**MEMORANDUM**

TO: District of Columbia Zoning Commission

DATE: November 25, 2015

SUBJECT: ZC 14-24: Map Amendment from the R-4 to R-5-B Zone for Square 2848, Lots 39, 40, 72 and 838

Figure 1

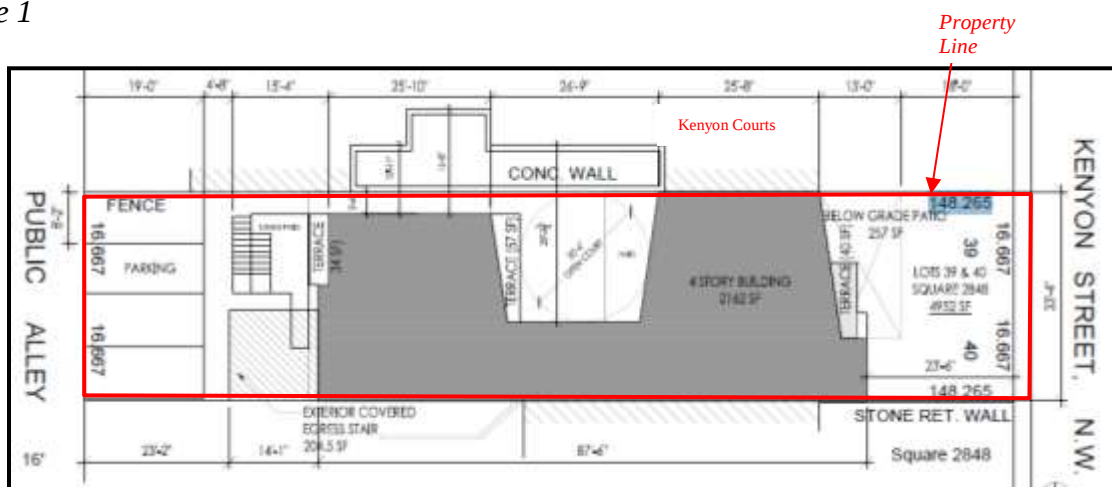
The Applicant has carved out an open area on the west side of the building similar to that on the building to the west, Kenyon Street Yes We Can Cooperative (*Figure 1 below*) to provide additional light and between the buildings. The Kenyon Street Yes We Can Cooperative building has a setback of between 7.41 feet and 13.12 feet from the property line and the proposed building would be setback an additional 3.5 feet to 24.66 feet from the property line. The setbacks combined would reduce clear sight views from the proposed development through to the windows on the Kenyon Street Yes We Can Cooperative building. Additionally, the terraces off the units which are in the court area are angled so that direct views to the windows on the adjacent building are minimized. Other terraces on the rear and the front of the units would not significantly impact the light to adjacent buildings to the east and south of the development.

The Applicant has provided light studies which show that the loss of light to the lower units on the Kenyon Street Yes We Can Cooperative building could be more affected by a matter-of-right R-4

development than the proposed development. To minimize the impact on the Kenyon Street Yes We Can Cooperative, the southern portion of the proposed building would be setback 3.5 feet from the property line as well as providing the court area adjacent to the existing court area on the Kenyon Street Yes We Can Cooperative building.

With the southern portion of the building setback from the property line, there have been concerns regarding the security of the units on the ground floor of the Kenyon Street Yes We Can Cooperative. Similarly, there is a concern for privacy of Kenyon Street Yes We Can Cooperative lower level units which would be adjacent to the open patios on the ground of the proposed building. To address both the privacy and the security issues, the applicant would build a fence along the Kenyon Street Yes We Can Cooperative open area. At the time of this report, the Applicant states that they are still in discussions with the Kenyon Street Yes We Can Cooperative as to their preference in the type, materials and height of the fence. The privacy of adjacent buildings to the east and south of the development would not be significantly impacted by due to the distance between the buildings.
